STAFF RECOMMENDATION
2807 27th Avenue South
November 15, 2017

Application: New Construction – Addition; Partial Demolition
District: Hillsboro-West End Neighborhood Conservation Zoning Overlay
Council District: 18
Map and Parcel Number: 1703000900
Applicant: Manuel Zeitlin
Project Lead: Melissa Baldock, melissa.baldock@nashville.gov

Description of Project: Application is to construct a rear addition with an attached garage at the basement level. The project includes demolishing the existing porte cochere and constructing a new one in its place.

Figure 9 (Left) is a photo of the existing fenestration pattern on the right facade, and Figure 10 (right) is a drawing of the new fenestration pattern. The area of the proposed new door opening is indicated with the red box.

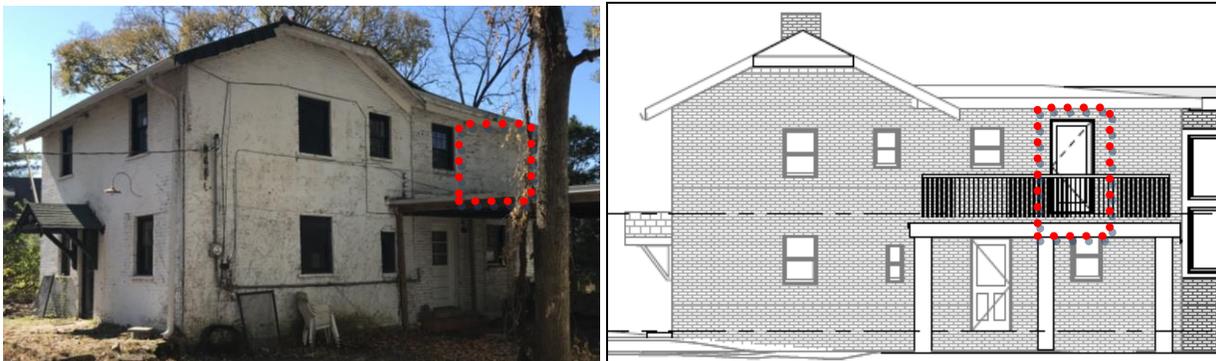
The applicant is proposing to alter some window and door openings on the side façade, which is considered partial demolition. On the right façade, second level, a window opening will become created in the brick wall (Figures 9 & 10). On the left façade, a door opening on the upper level will be filled in, and a door on the first floor will be filled in and a new window opening created (Figures 11 & 12). Staff finds the window and door alterations to be appropriate because they are located on the back portions of the side facades, where fenestration pattern is less integral for the historic character of the house. Also, the house is so far back on the lot that the window alterations will not be highly visible from the street.

Staff finds that the demolition of the porte cochere and the shed and the alteration of the window and door openings on the historic house meet Section III.B.2 for appropriate demolition and do not meet section III.B.1 for inappropriate demolition.

Figure 13. The extra height of the addition is minimized by the hipped roof form. Only a small triangle of extra height is visible at the front elevation.

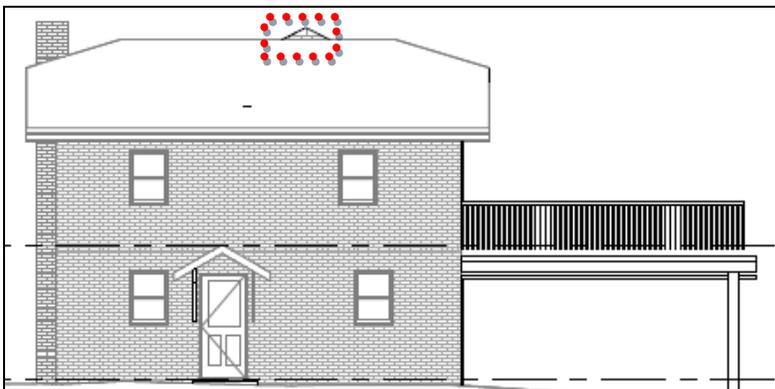
Height & Scale: The historic house is two stories with an eave height of fifteen feet (15') at the front as measured from grade and a ridge height of twenty-two feet (22') at the front. The rear addition will also be two stories and will have an eave height to match that of the historic house. The addition's ridge rises to be one foot (1') taller than the historic house. Typically, MHZC does not allow additions to two-story houses to be taller than the historic house. However, staff, in this instance, finds the extra one foot (1') of height to be appropriate for several reasons. First and foremost, the extra height does not occur until more than fifty-feet (50') back from the front wall of the house. Because the house is setback more than one hundred feet (100') from the front property, and is unique in that sense, the extra height of the addition will not be highly visible from the street. In addition, although two stories in form, the historic house is just twenty-two feet (22') tall, which is short for a two-story structure and which is shorter in height than many of the historic one-and-a-half story houses in the immediate context. The addition's extra one foot (1') of height will not create a structure that is overly tall for the historic context. Lastly, the addition's separated hipped roof form ensures that only a small triangle of the addition rises above the roof at the front and that the new construction has minimal impact on the historic form (Figure 13). For these reasons, staff finds the addition's height to be appropriate.
